Date: April 23, 2024
To: All Prospective Bidders
From: Sam Li
Interim Director of Procurement Services
Re: Addendum Number 2
IFB # C1629 – COED Residence Hall Closet Treatments, Floors 13-15

PROJECT:
 COED RESIDENCE HALL
 CLOSET RENOVATION
 FLOORS 13-15
 230 W 27TH STREET
 NEW YORK, NY 10001

DRAWING TITLE:
 LOCATION PLAN -
 FLOORS 13-15

1 TYPICAL LOCATION PLAN - FLOORS 13-15
 6-002 SCALE: 3/16" = 1'-0"

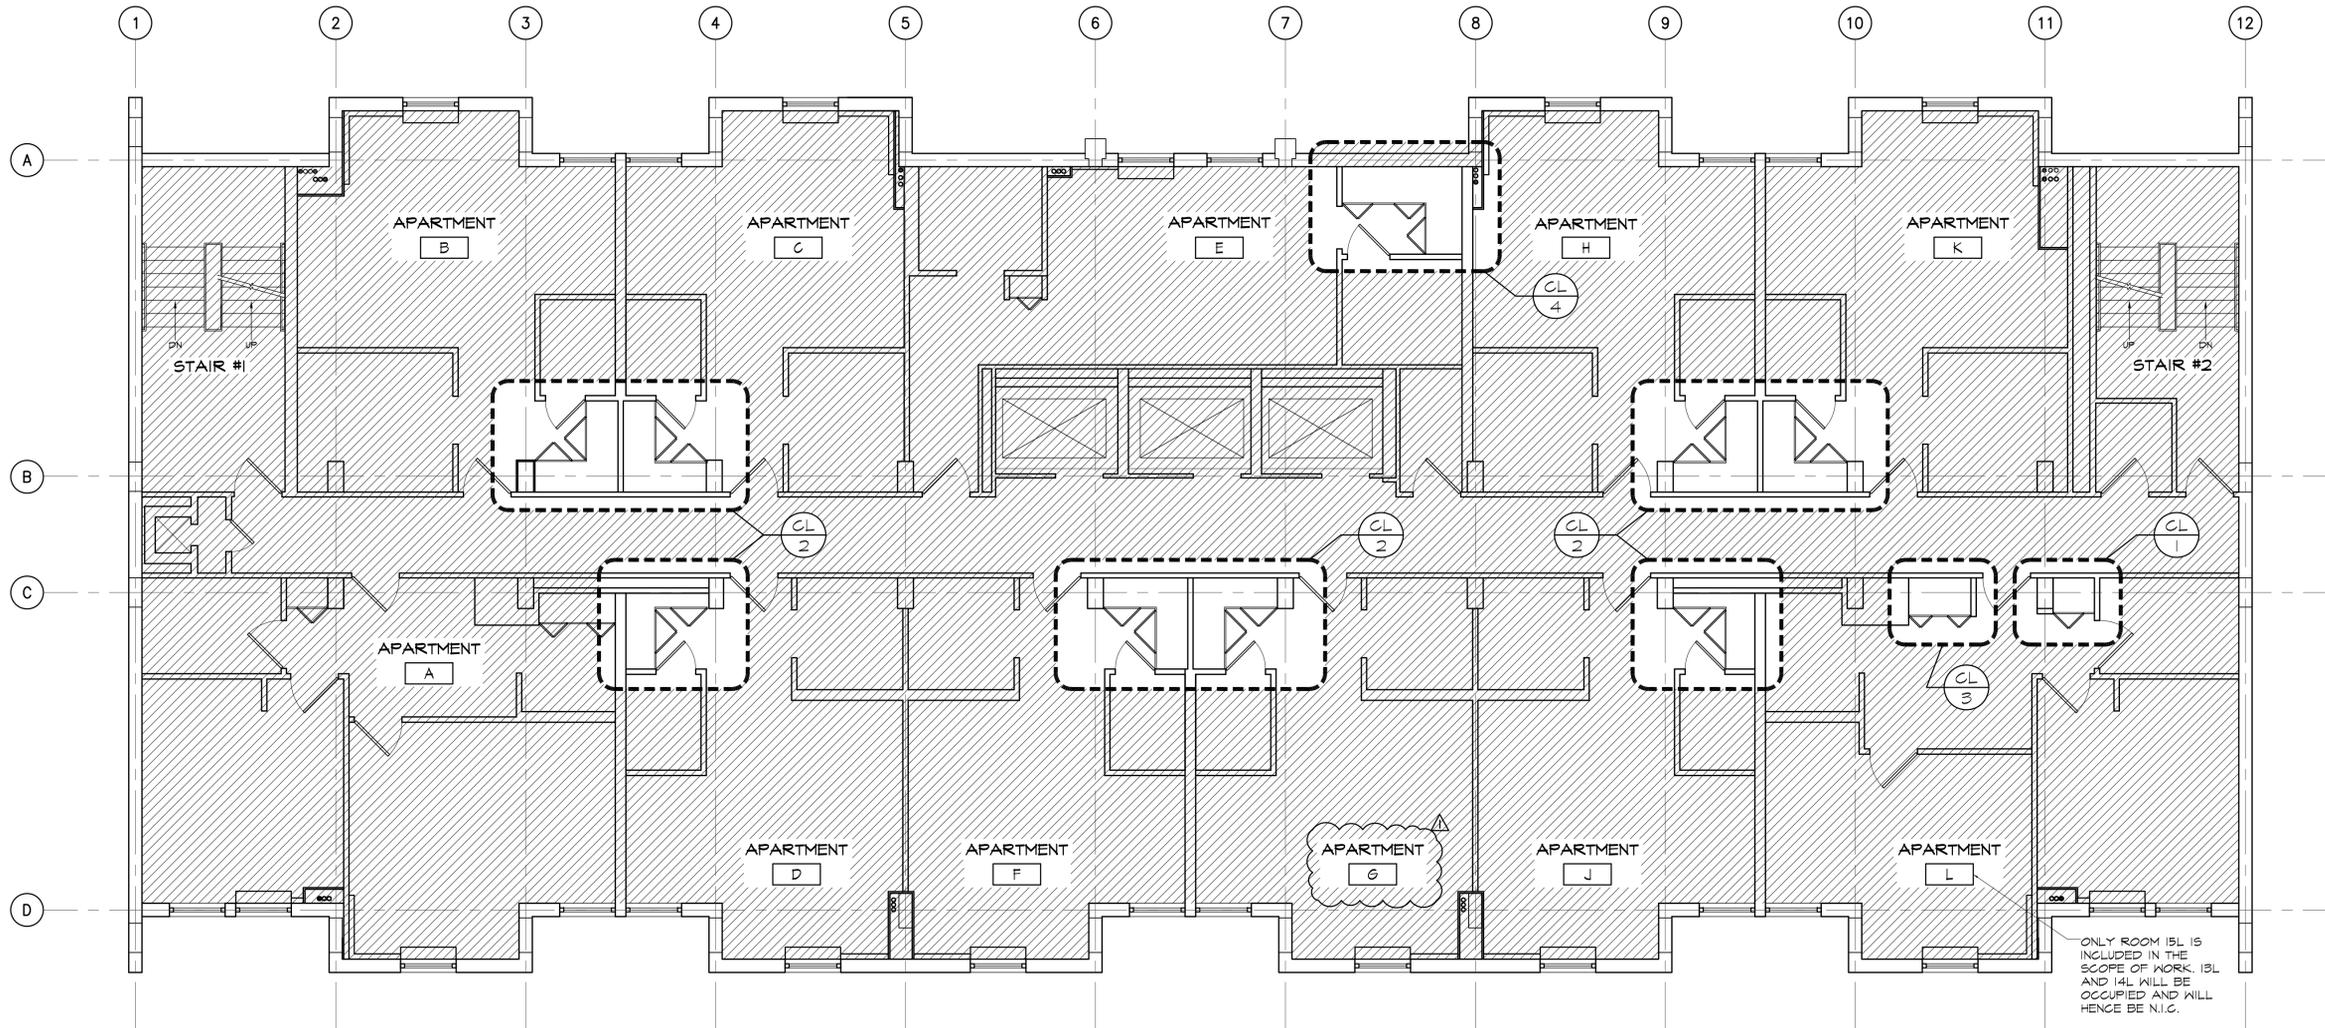
- Q1. On the plans, where G would be it shows it as K room. We are omitting rooms 13A, 13L, 14A & 15A. Please confirm there is no work in these rooms. On the COED Residence Hall Closet Treatments project from the prior year, we encounter an issue with obtaining the shoe racks on time. These shoe racks can only be obtained through Home Depot and the manufacturer will not sell to us directly. Home Depot only stocks a limited amount of these shoe racks. You may want to consider a substitute if possible, otherwise expect a long lead time.

- A1. See attached G-002.SK1 with revised room numbers. Rooms 13A, 13L, 14A, 14L & 15A are not included in the scope of work. Sourcing the shoe racks from multiple Home Depots or online in a timely manner will ensure the material is on site in ample time. Contractor is able to propose an 'or equal' substitution from an alternate manufacturer. Substitutions to be reviewed and approved by the Architect, as per Contract.

1. ROOM 13A, 13L, 14A, 14L & 15A WILL BE OCCUPIED BY PROFESSIONAL STAFF DURING CONSTRUCTION. THERE IS TO BE NO WORK IN THOSE ROOMS. ACCESS TO AND EGRESS FROM THESE ROOMS MUST BE MAINTAINED AT ALL TIMES.
